## RTCA Special Committee 186, Working Group 3

## ADS-B 1090 MOPS, Revision A

### **CPR Clarification**

1090-WP-14-16R1 Page 1 of 5

Figure 1. Encoded values of latitude for surface formats.

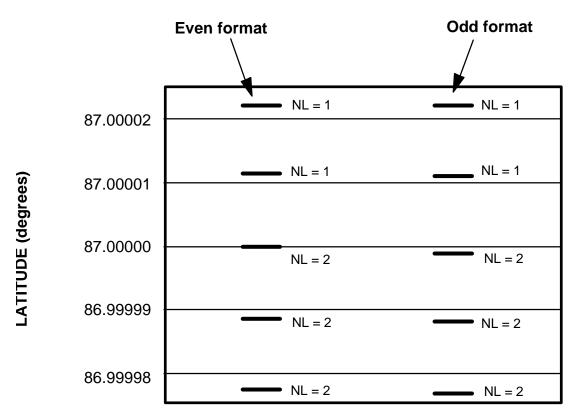
<u>Last row of Table 2-90</u>. While working on this, I revisited the issue that first raised a concern, which was the last row of Table 2-90. Ian Levitt had done some work on this, and with Jim Maynard's help had developed replacement values for the entries in this row. The values are documented in the minutes from meeting #2.

I studied this issue again by making the diagram shown below in Figure 1, which identifies the encoded latitude values near 87 degrees. Because rounding-off is done in the encoding process, it follows that the real value of latitude where the change occurs from NL=2 to NL=1 is midway between the discrete values in the diagram. Therefore the table entries should be comfortably somewhat away from the change point -- and they are. I'm satisfied that the table entries are appropriate as we agreed in meeting #2.

Figure 2. Encoded values of latitude for airborne formats.

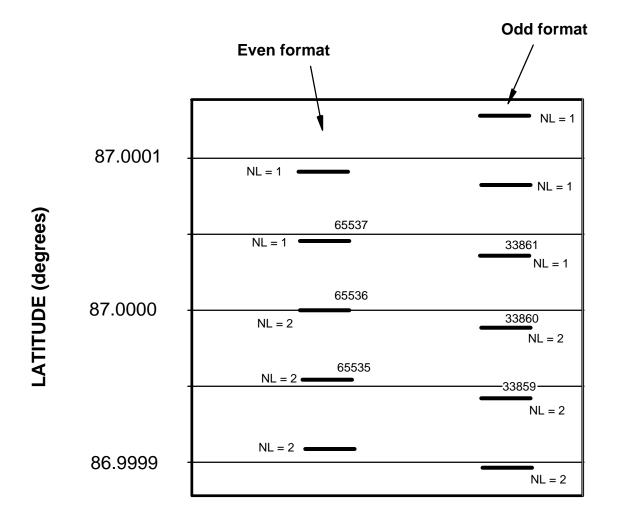
Supporting Figures. The following figures are provided for more detailed information. Figure 2 is similar to Figure 1, showing the encoded latitude values for airborne formats, whereas Figure 1 applies to surface formats. The final figure illustrates the nature of the multiple CPR solutions at mid latitudes and near the north pole. These apply when a single Extended Squitter message is received of even format.
